ArevaEPRDCPEm Resource

Subject: Response to U.S. EPR Design Certification Application RAI No. 547 (6499, 6359), FSAR Ch. 3 - NEW PHASE 4 RAI, Supplement 5

QUESTIONS for Structural Engineering Branch 2 (ESBWR/ABWR Projects) (SEB2)

Question 03.07.02-78**Open Item****Follow-up to RAI 371, Question 03.07.02-66 and RAI 376 Question 03.08.05-28.**

Figure 3.7.2-78-1: Shell to Solid MPCs for Tendon Gallery and Basemat Connection

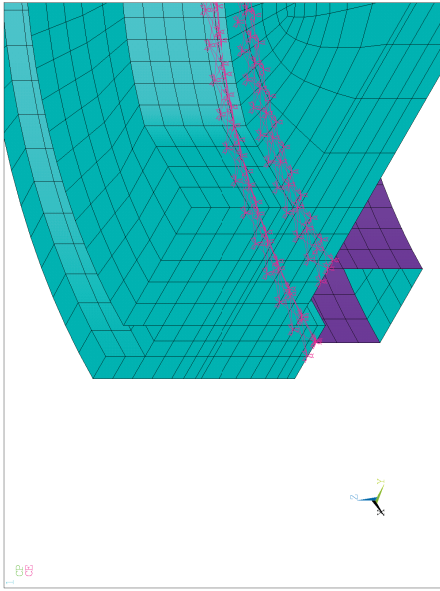
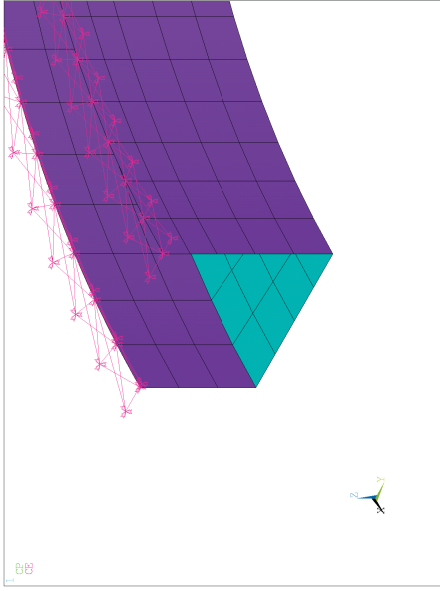
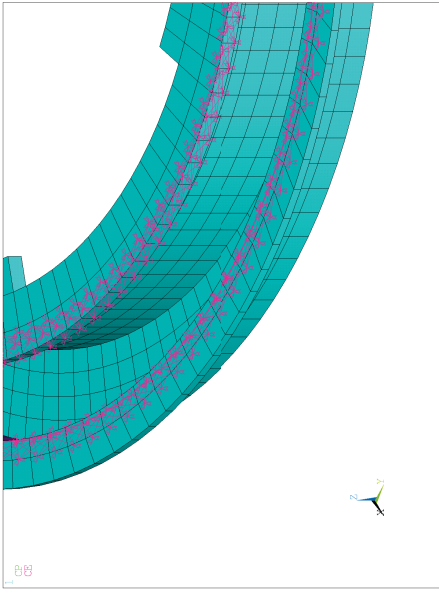
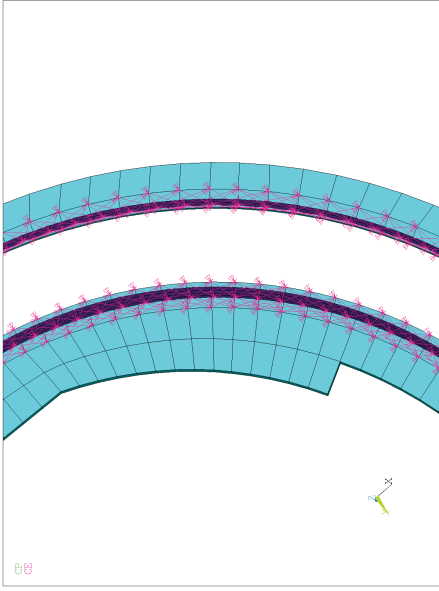
The tendon gallery acts as a shear key under seismic loads. The seismic loads need to include the effect of any localized movement of the basemat. Determining the additional loads due to movement of the basemat is accomplished by performing two separate analyses. In the first analysis, uplift and sliding of the basemat is not allowed. In the second analysis, uplift and sliding is permitted. The difference in the pressure between these two cases is a delta pressure which is added to the lateral loads determined from the SASSI SSI analysis of the NI. For the two rock cases which appear to provide the highest sidewall pressure loads on the shear key, the applicant states that the top ring of nodes of the tendon gallery are connected to the solid element basemat using ANSYS shell to solid Multi-Point Constraints (MPCs) and have no sidewall rock springs. The bottom ring (elevation) of nodes of these shell elements that are connected to the basemat have stiff sidewall rock springs that simulate partially fixed boundary conditions. These nodes experience higher pressures and moments (stress concentration effect) typically associated with fixity. For these cases, average maximum pressure values considering a full element instead of a node are presented in Table 03.07.02-66-2. As it is not clear from the applicant's explanation which nodes or elements are being described and what is meant by partially fixed boundary conditions, the applicant is requested to provide:

- A figure depicting the boundary conditions for the shear key nodes and;
 - A figure depicting maximum pressure values and average pressure values over the complete height of the tendon gallery with a description of how the average values were calculated.

- The TG walls are modeled using shell elements (ANSYS SHELL43 elements) and connected to the solid element basemat (ANSYS SOLID45 elements) using ANSYS shell to solid Multi-Point Constraints (MPCs). Figure 3.7.2-78-1 shows the shell to solid MPCs. The bottom of the NI basemat solid elements is located at different elevations. The outer TG walls connect to the Balance of Nuclear Island portion of the NI common basemat at elevation -41ft and the inner TG walls connect to the RBIS/RCB portion of the NI common basemat at elevation -36 ft. Table 3.7.2-78-8 lists the nodes at different elevations of the TG and their boundary conditions.

Figure 3.7.2-78-7: SSI Pressure with and without scaling for Wall 2, Soil Case 1n2ue

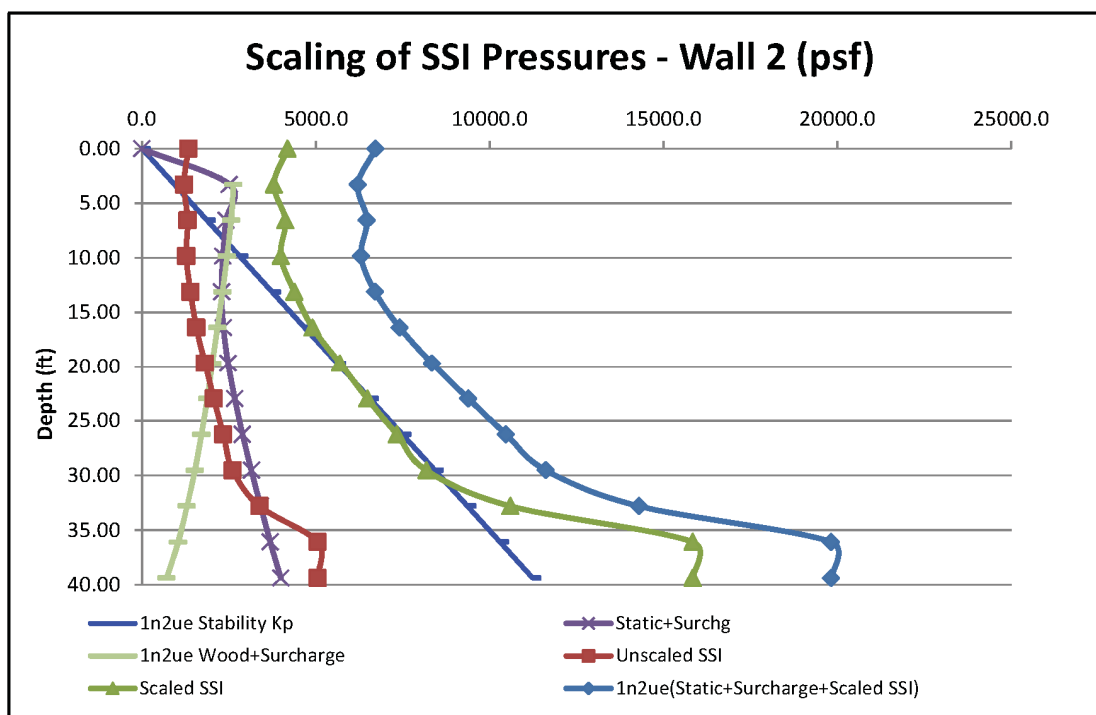
- (b) Provide a graphical explanation of the scaling of the SSI pressure profiles. Clarify whether this scaling is done at each depth so that the scaled SSI pressure profiles always bound the linear $K_p=3.0$ pressure profile, or whether the scaling is done at one depth only using a single scaling factor applied to the entire profile. (It is stated that the maximum pressure on each wall is at least equal to the passive earth pressure of $K_p=3.0$).

- (b) Figure 3.7.2-78-7 illustrates the scaling of SSI pressures for a typical wall (Wall 2) and soil case (1n2ue). The scale factor for a given soil case corresponds to the ratio of the maximum passive pressure to the maximum SSI pressure along the depth of the embedded wall. The (single) scale factor is applied to the SSI pressure profile (along the depth of a wall) for a given soil profile. For Wall 2 with soil case 1n2ue, the maximum SSI pressure (at depth of -38.9 ft) is 5,054 psf, and the maximum passive pressure at this depth is 15,835 psf. The scale factor is calculated as 3.13. This scale factor is applied to the SSI pressures (labeled "Unscaled SSI") at various depths to arrive at the scaled SSI pressures (labeled "Scaled SSI").

Figure 3.7.2-78-8: Wall 2 - Soil 1n2ue & 1n5aeh (Cracked Concrete Case)

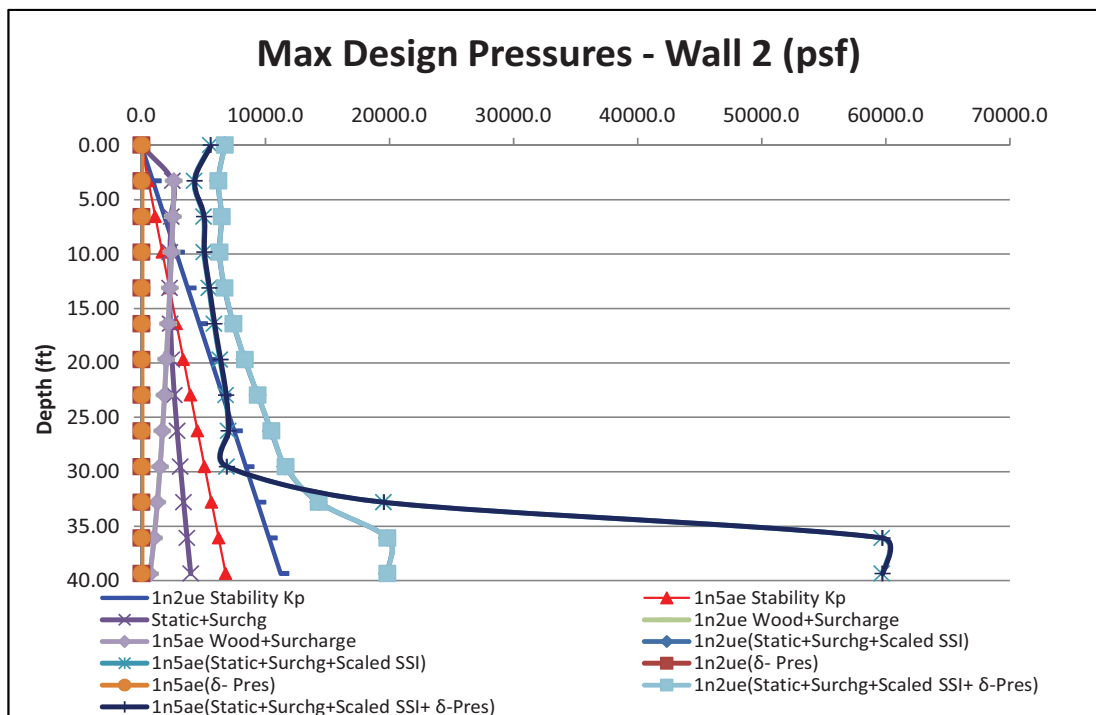
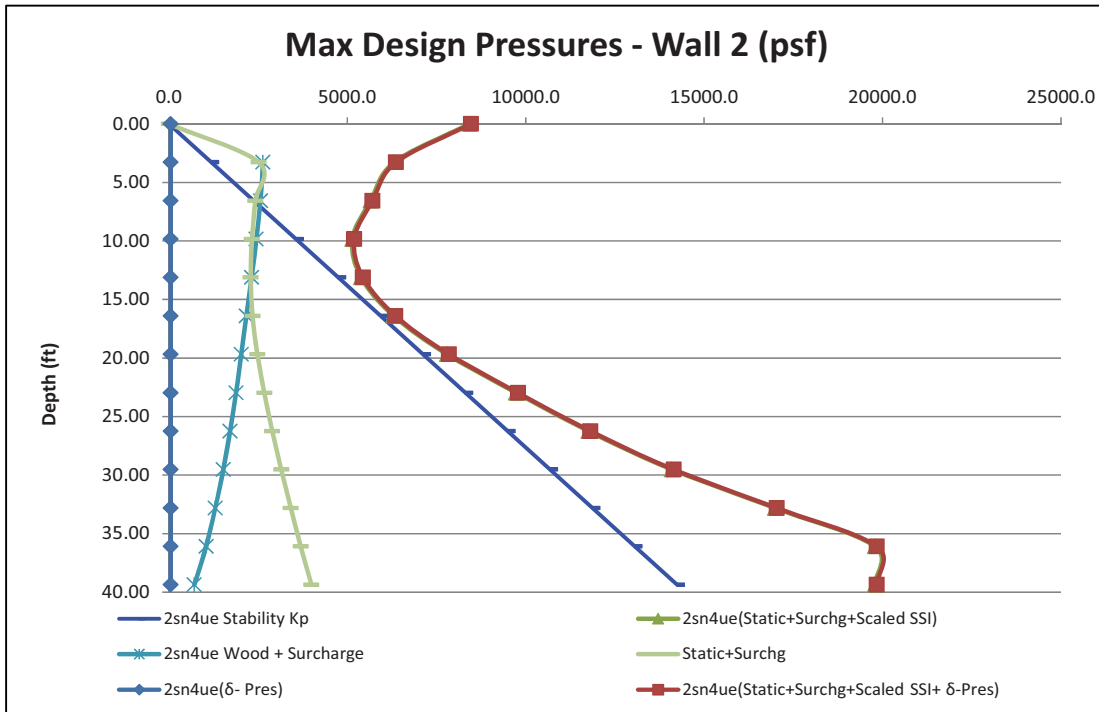
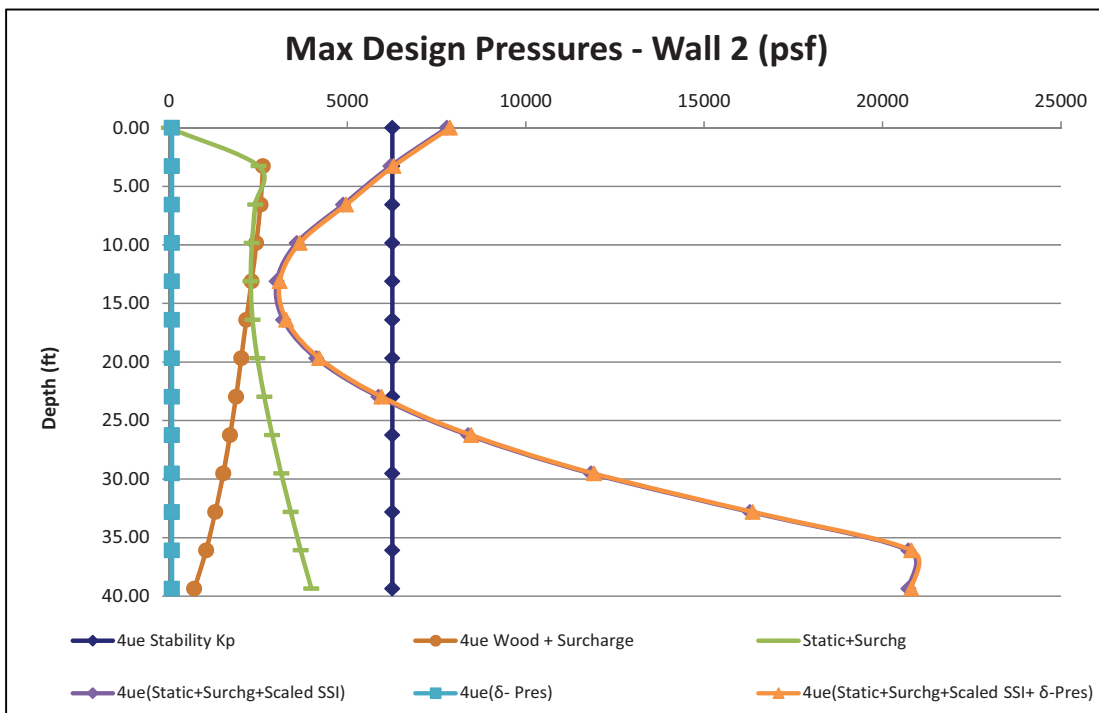
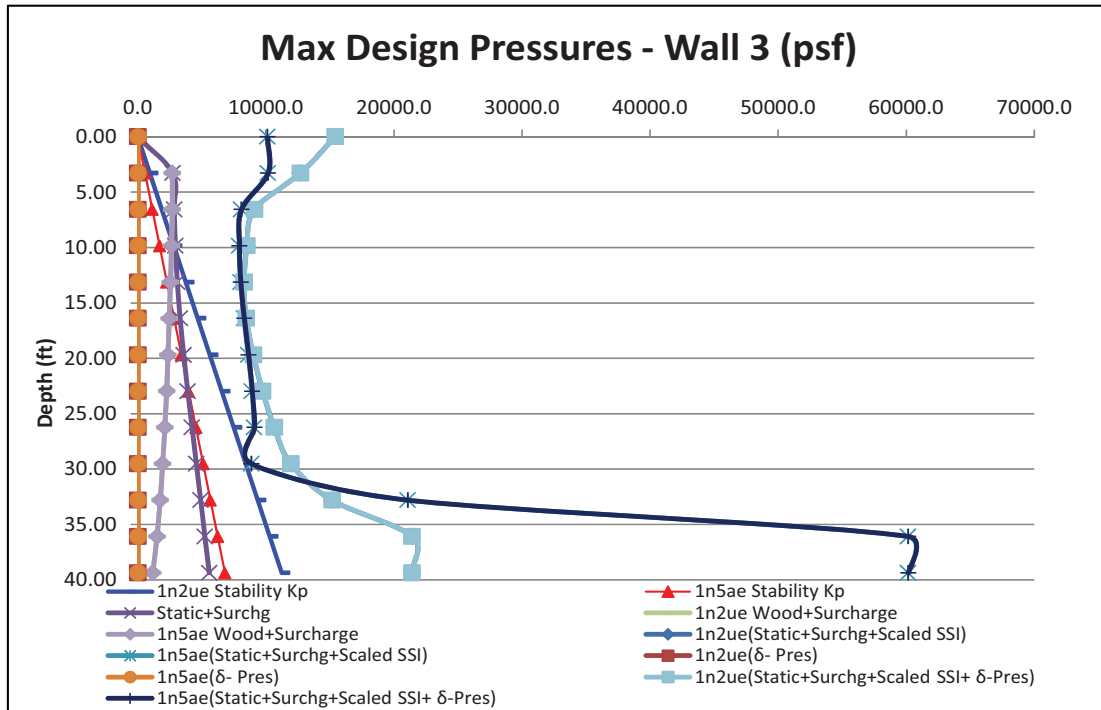
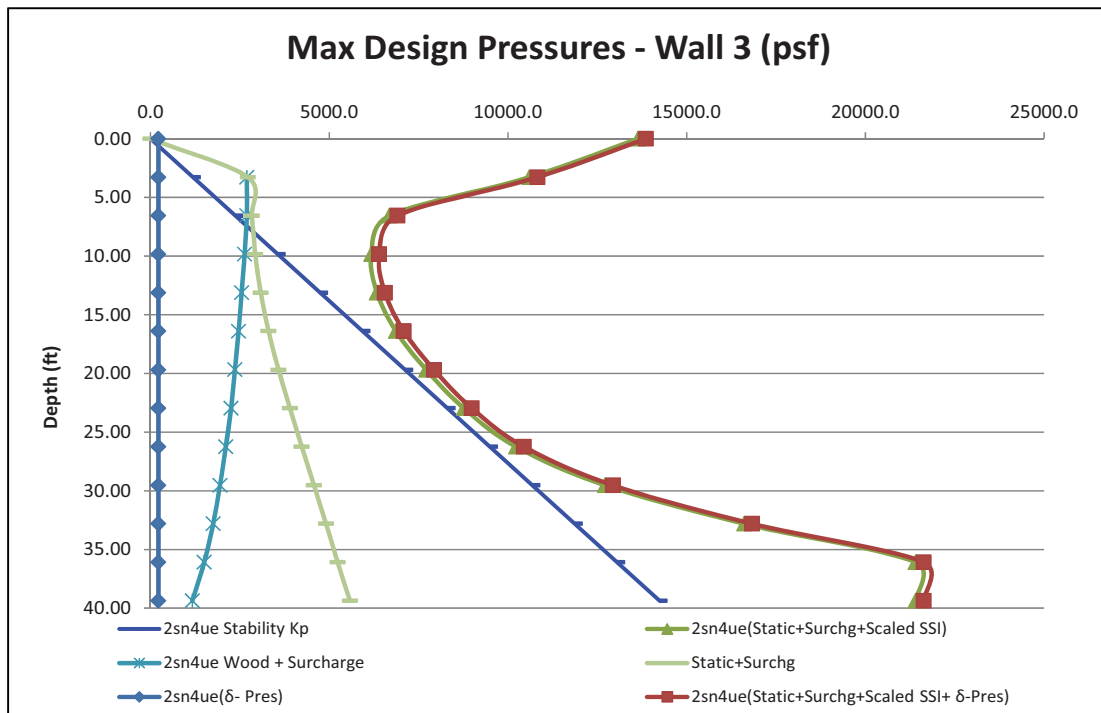
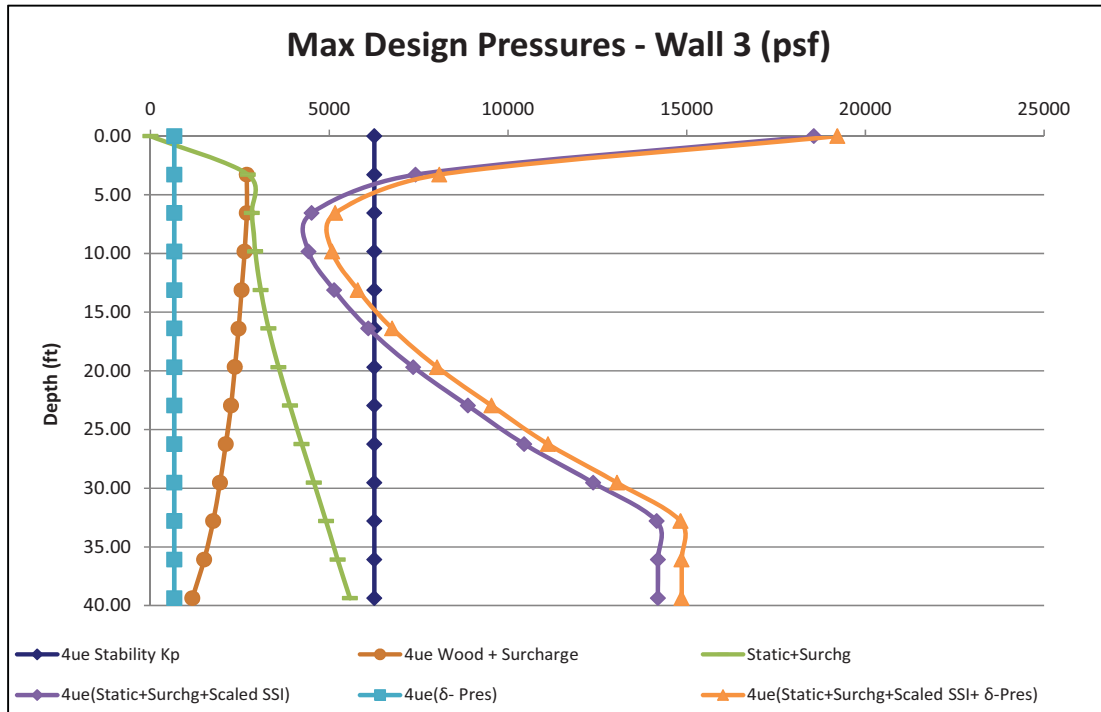
- (a) To ensure that the referenced figures in RAI 376 Question 03.08.05-28 provide a consistent comparison, confirm that all the pressure profiles shown represent the combined effect of static plus surcharge plus seismic loads, including the profiles identified as Wood's solution. How are the static and surcharge loads combined with the scaled SSI pressures and to the passive pressures from the stability analysis?

- (c) A review of the referenced figures indicates that, for a given wall, soil, and analysis case, it does not appear to be always true that the scaled SSI pressure profile always bounds the pressures required by the sliding stability analysis. For example, in Figure 03.08.05-28-5 (Wall 2, "cracked" analysis) the vertical "4uem Stability K_p " profile (blue line) is greater than the "4uem" profile (magenta line) at depths between approx. 5 ft. and 25 ft. A similar situation is observed in Figure 03.08.05-28-61 (Wall 2, "uncracked" analysis). This is due to the difference in the relative shape of the two pressure profiles. Since the applicant indicates that it is not using an envelope of all soil cases (such as the ones shown in Figures 03.08.05-28-42 through 03.08.05-28-59 and Figures 03.08.05-28-98 through 03.08.05-28-115), but is considering each soil case independently, explain how

- (c) The combined static, surcharge, delta pressure, and scaled SSI pressures generally bound the pressures required by the sliding stability analysis (SSI analysis). The example cited in the Response to RAI 376, Question 03.08.05-28, corresponds to the soil case 4uem for which a uniform soil pressure of 43.5 psi for the walls and 50 psi for the TG was applied to provide the minimum factor of safety for sliding. Note that for soil case 4uem, the scaled SSI pressure with static, surcharge and delta pressures do not bound the stability pressure case at certain local sections of the wall (between roughly 5 ft. and 25 ft. from the top). However, Figure 3.7.2-78-46 through Figure 3.7.2-78-55 show that other soil cases would govern the design of the walls; and, in fact, exceed the stability pressure requirements of soil case 4uem. In soil case 2sn4uem for walls 5 and 11, only minor sections of the wall were not bounded by the scaled pressures. However, the design of the wall would be governed by the larger sidewall pressures at the top and bottom of the walls where the scaled SSI pressures are significantly greater than the stability pressures.

- (d) Figure 3.7.2-78-8 through Figure 3.7.2-78-37 show the stability (K_p); static and surcharge; Wood's and surcharge; static, surcharge, scaled SSI and additional (delta) pressure due to localized sliding/uplift of the basemat; and the combined delta pressure, scaled SSI, static and surcharge for the embedded walls.

Figure 3.7.2-78-56—Bearing Pressure Distribution for Foundations

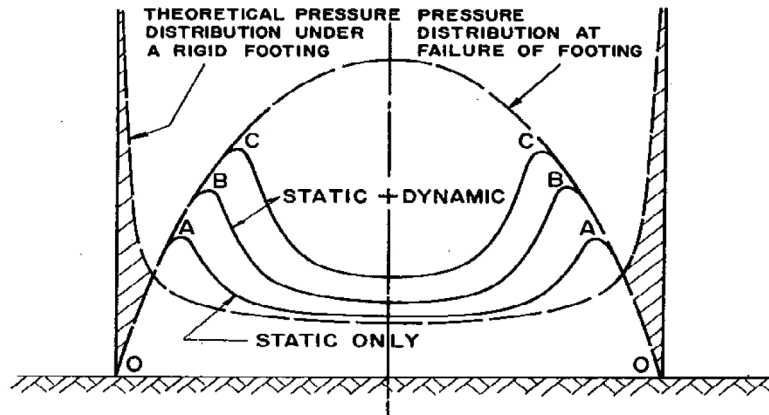
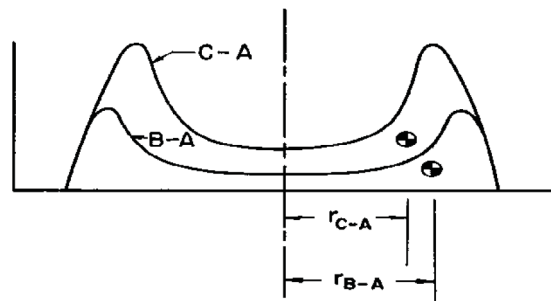
- (b) For the bearing pressure contour plots shown in Figures 3.8.5-28-A through 3.8.5-28-D, provide the technical basis for the process used to average the corner pressures, toe pressures, and any other localized pressure “hotspots.”

- (b) As reported in technical literature (see F.E. Richart and R.V. Whitman, "Footing Vibrations – Comparison of Test Results with Theory," University of Michigan, IP-755, November 1966) theoretical equations result in very high bearing pressures near the edges of the footing due to singularity. The authors present a more credible bearing (failure) pressure distribution shown in Figure 3.7.2-78-56 (reproduced from Richart's paper). In accordance with the postulated pressure distribution for combined static and dynamic loads, the bearing failure point moves away from the edge of the footing. Though the paper does not provide specific guidelines for averaging pressures near the edges (and corners), it does point to the need for a more realistic treatment of the theoretically derived peak pressures near the edges; and, thus, any FEM analysis. Therefore, averaging of the bearing pressures over the corner and edges of the basemat is considered to be a reasonable approach to estimate the corner and edge pressures.

Figure 3.7.2-78-57: Case 1n2ue, Cracked, Time Snapshot of the Dynamic Bearing Pressure at Max Dynamic Bearing Pressure Time(s)

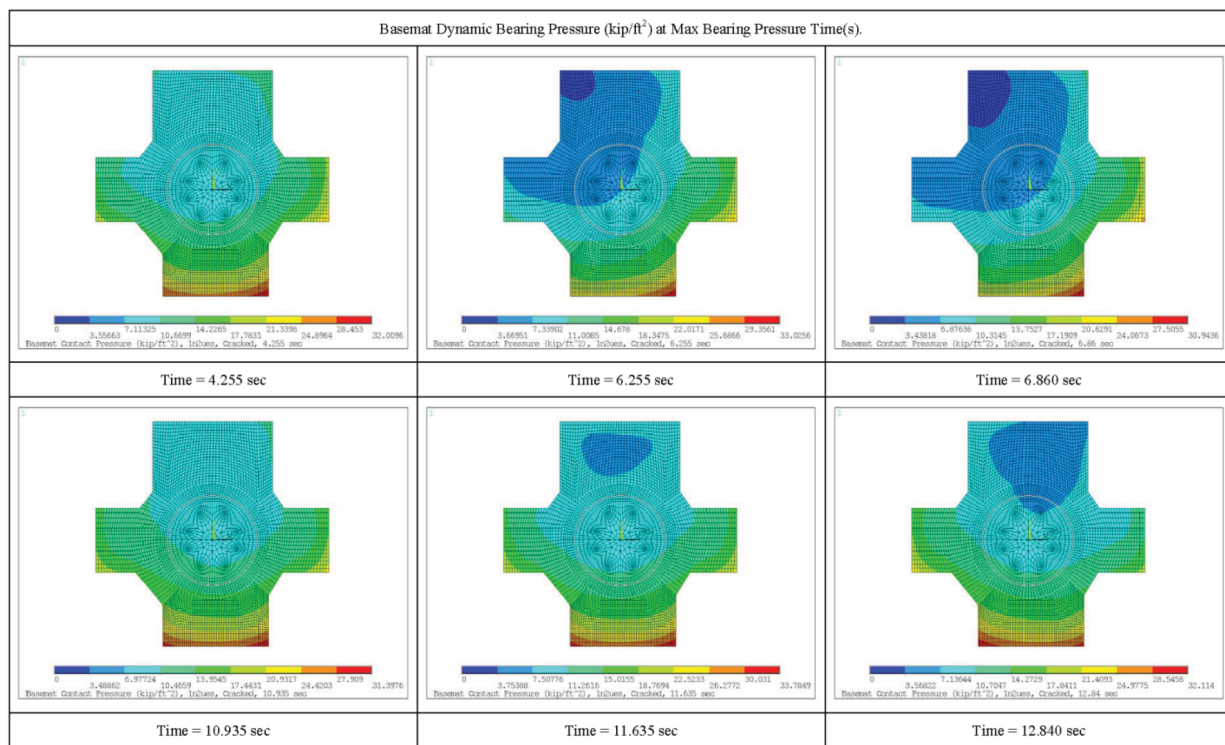
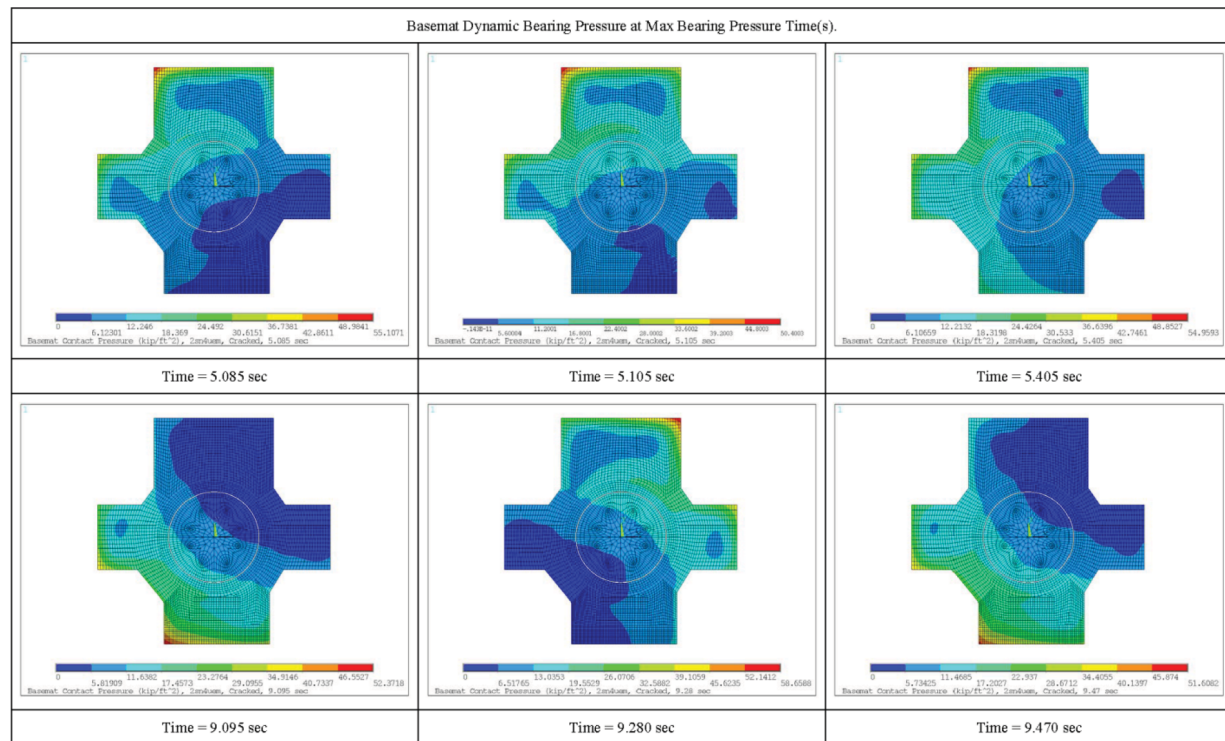
- (d) Item 5(e) of the RAI response indicates that the ANSYS 3D FEM basemat model results were compared to the SASSI FEM model results. Since the reported bearing pressures are obtained from the SASSI FEM model results, provide bearing pressure contour plots similar to those in Figures 3.8.5-28-A through 3.8.5-28-D, obtained from the ANSYS 3D FEM basemat model. Discuss the comparison between the two sets of results.

- (d) Bearing pressure contour plots generated from the ANSYS 3D FEM basemat model are shown in Figure 3.7.2-78-57 through Figure 3.7.2-78-60. These contour plots correspond to soil cases 1n2ue, 2sn4uem, 4uem, and 5aeh, respectively; and correspond to the SASSI-generated contour plots with similar soil cases shown in Figure 3.8.5-28-A through Figure 3.8.5-28-D in the Response to RAI 376, Question 03.08.05-28. The contour plots shown for the ANSYS results represent the bearing pressures without any averaging, whereas the SASSI contour plots show averaged corner and edge pressures. The two sets of results are comparable.
